IMPORTANT SAFETY RECALL

Date: 10/15/18
To: WTE5C/WTE5HP Series Water Trailers Owners
From: Multiquip Product Department
Subject: Trailer Axle Replacement — **Mandatory Update**

Service Bulletin

WTE5C/WTE5HP Series Water Trailers

Figure 1. Electric Axle Service Kit (TRLR70)

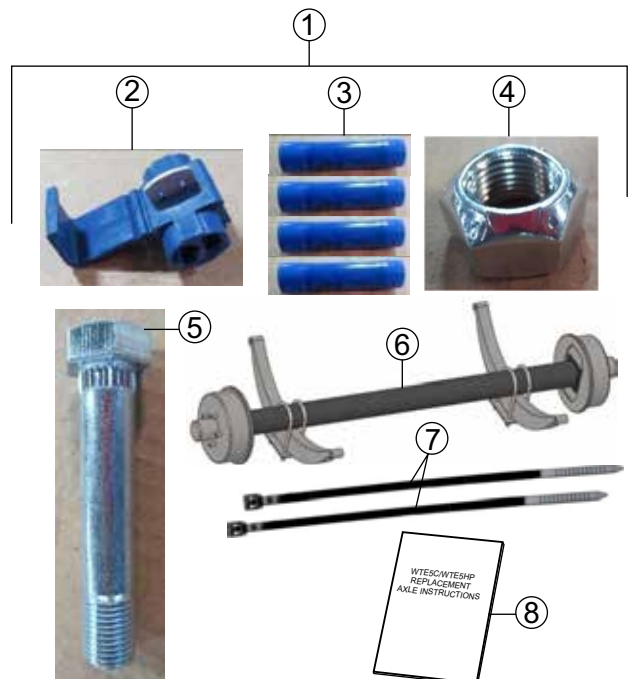
- A select number of water trailers were shipped with axle assemblies that do not meet with proper axle load ratings (GAWR).

- Replace existing axles with proper rated axle assemblies.

Table 1. WTE5C/WTE5HP Axle Service Kit				
Item No.	Part No.	Description	QTY.	Remarks
1	29396-SK	Assembly AxleTRLR70 Electric Service Kit	1	Includes items 2-8
2	19761	Splice Terminal	12	
3	2540	Wire Butt Conector	16	
4	29249	Axle, Hex Nut 9/16"-18 N-2	16	
5	29248	Axle, Mount Screw 9/16"-18 X 3"	16	
6	29396	Axle, Electric Brake Assy. 3,500 lb (1,587 kg) Capacity	2	
7	1662	Cable-Tie	8	
8	49498	Instruction Sheet	1
